ENGINE - HP COMPRESSOR - VSV SYSTEM RIGGING PIN BRACKETS WITH SLOTTED HOLES - CATEGORY
CODE 6 - MOD.ENG-72-0181

V2500-ENG-72-0181

This Service Bulletin introduces rigging pin brackets at stages 3 to 6 with axially slotted holes.

Location of bracket
Fig.1, Sheet 3 of 4

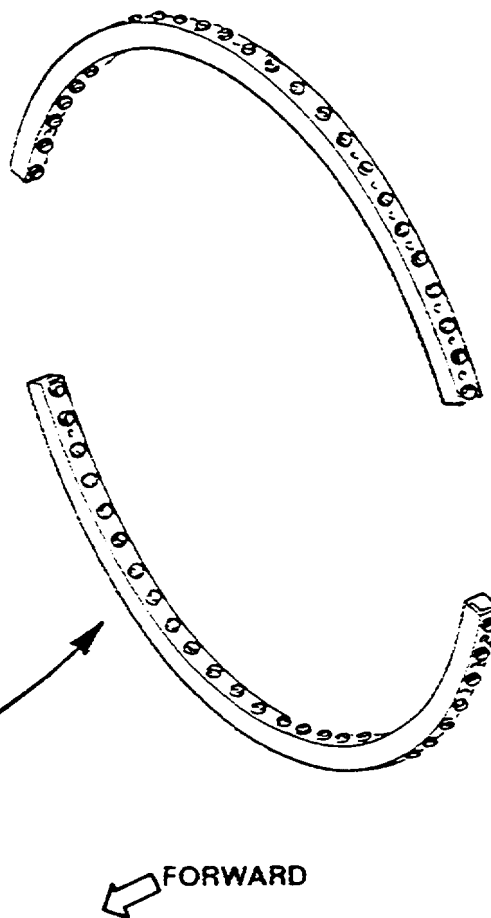
REMOVE 6A3876 BRACKET AND
INSTALL 6A5460 BRACKET

View showing stage 3 rigging bracket - Before and after alteration
Fig.3

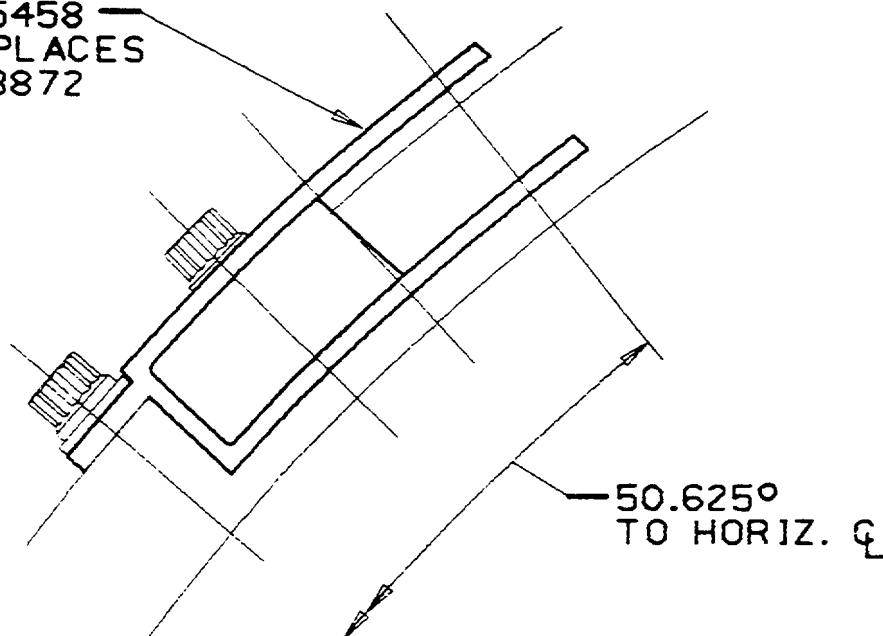
6A5458
REPLACES
6A3872

VIEW AT **AF**

View showing stage 4 rigging bracket - Before and after alteration
Fig.4

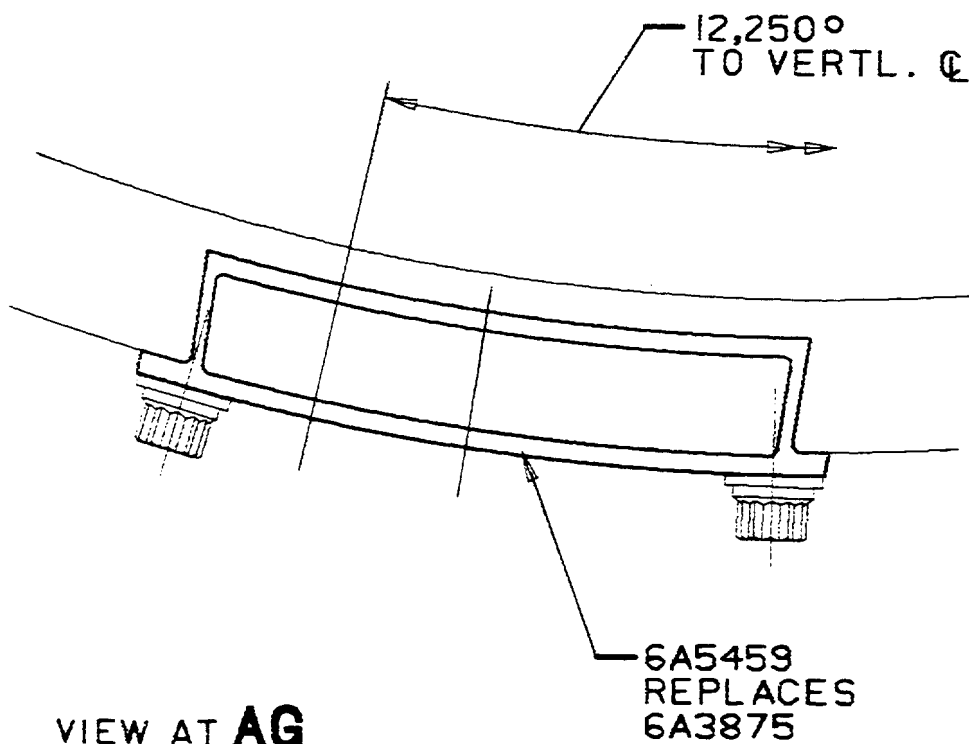
DIAGRAMMATIC SECTION **AC** (SEE FIG 2)

View showing stage 5 rigging bracket - Before and after alteration
Fig.5

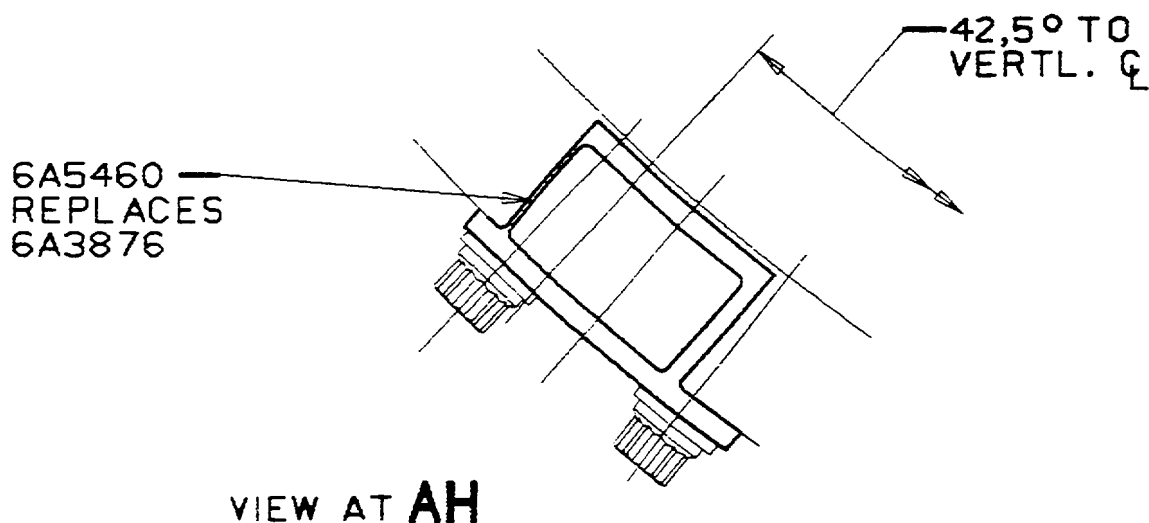
DIAGRAMMATIC SECTION **AD** (SEE FIG 2)

View showing stage 6 rigging bracket - Before and after alteration
Fig.6

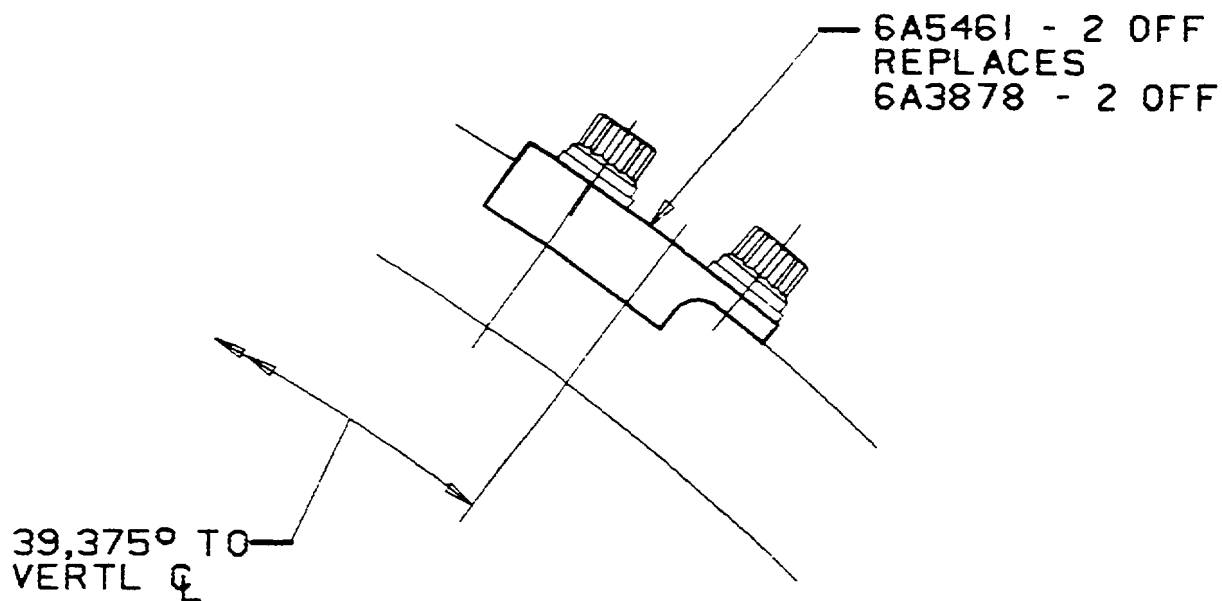
REPEAT DIAGRAMMATIC SECTION **AE** (SEE FIG 2)

TYPICAL VIEW AT **AK**

View showing stage 7 rigging bracket - Before and after alteration
Fig.7

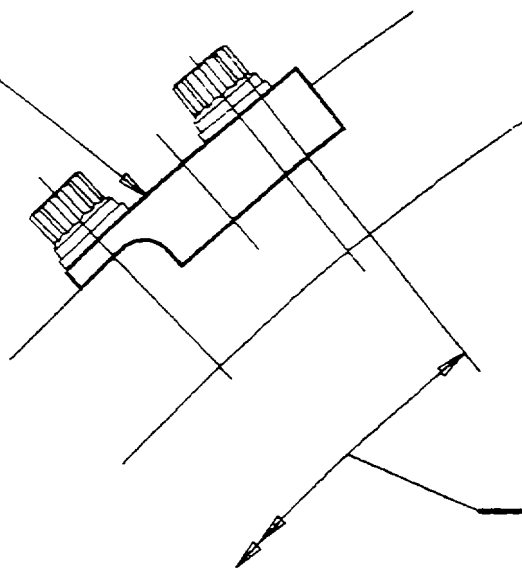
6A5462
REPLACES
6A3879

VIEW AT **AJ**

Rework of existing stage 3 brackets (6A3872)
Fig.8

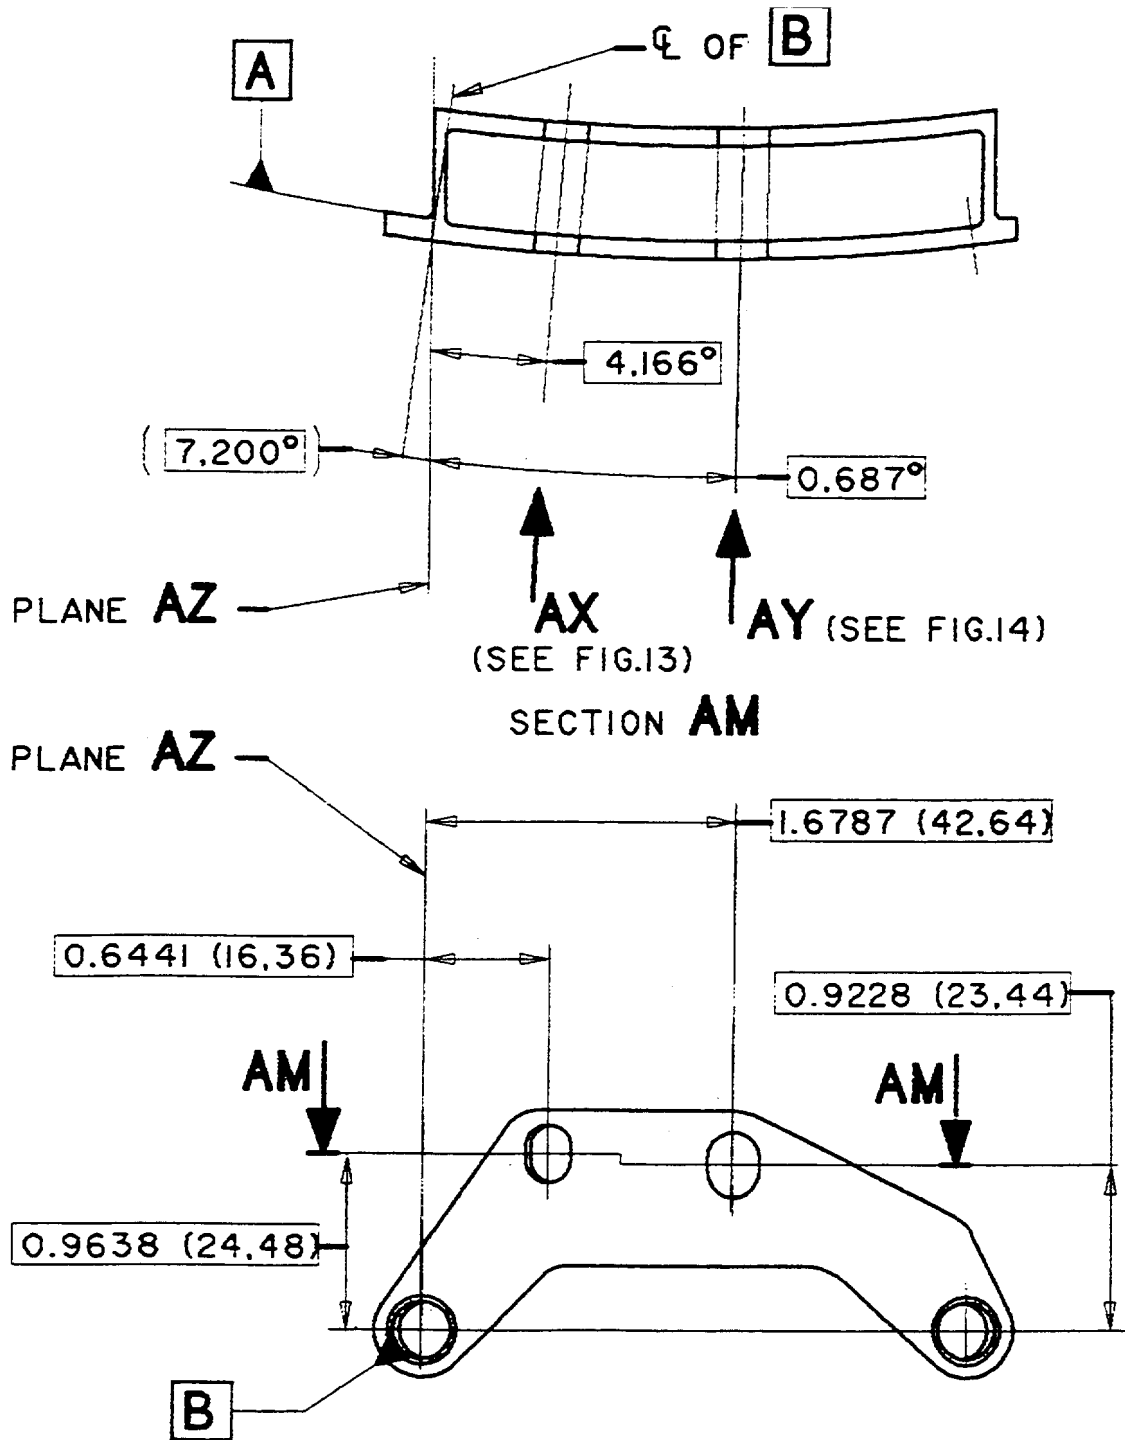
| (b) Machine the brackets to elongate the holes | See Figures 8 thru 14.

- (f) Do a crack test Refer to SPM TASK 70-23-02-230-501. Use penetrant crack test equipment
- (g) Measure the dimensions See Figures 8 thru 14. Reject if slots are oversize

| 6A3872 | 6A5458 |

Rework of existing stages 3 to 6 rigging brackets
Fig.13

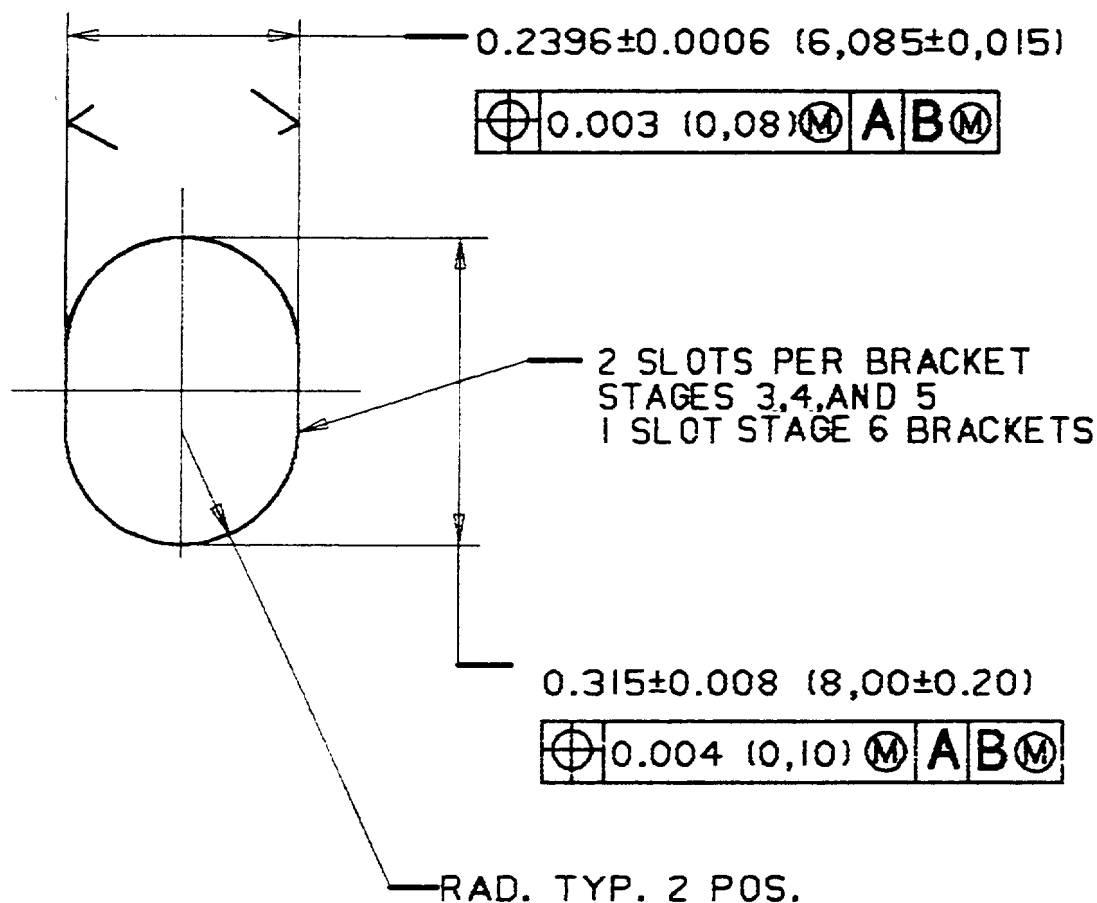
VIEW ON ARROW **AX** (SEE FIGS 8,9,10,11 & 12)
SHOWING MACHINING OF SLOTTED HOLE

Rework of existing stages 3 to 6 rigging brackets
Fig.14

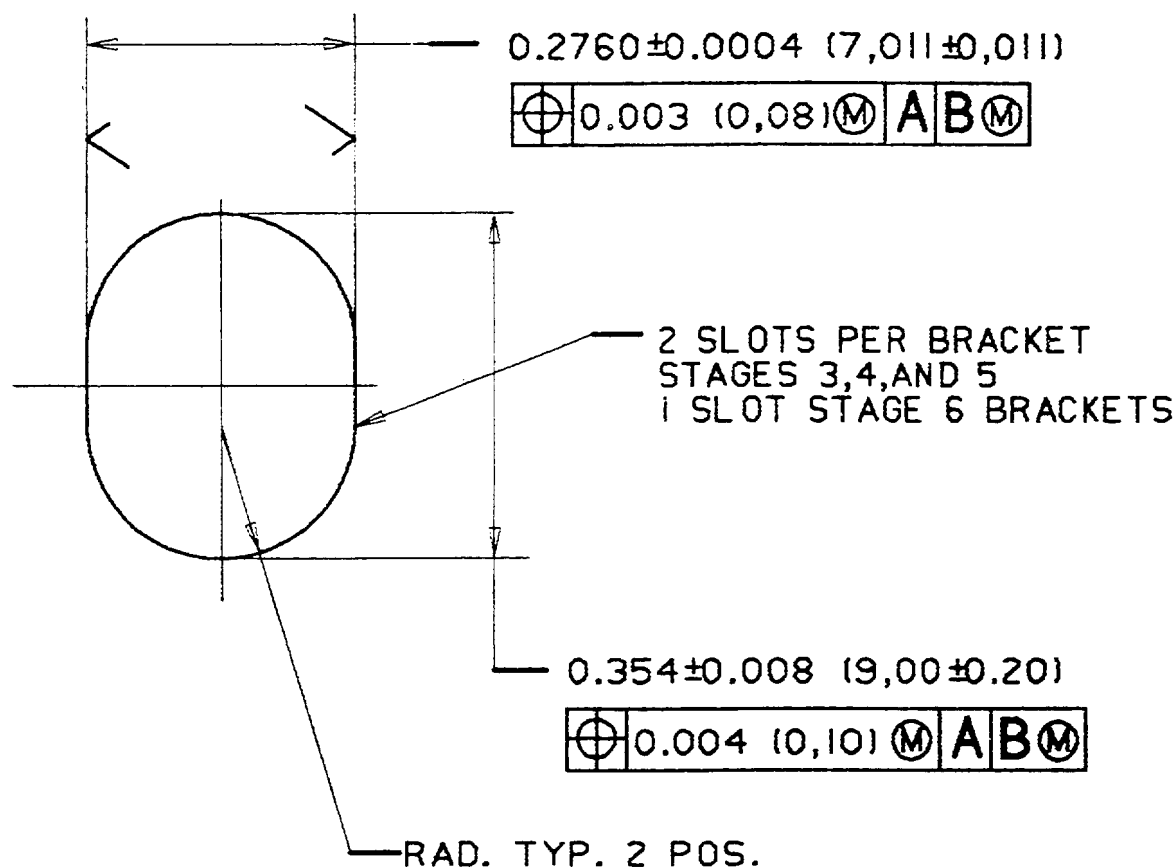
VIEW ON ARROW **AY** (SEE FIGS 8,9,10,11 & 12)
SHOWING MACHINING OF SLOTTED HOLE
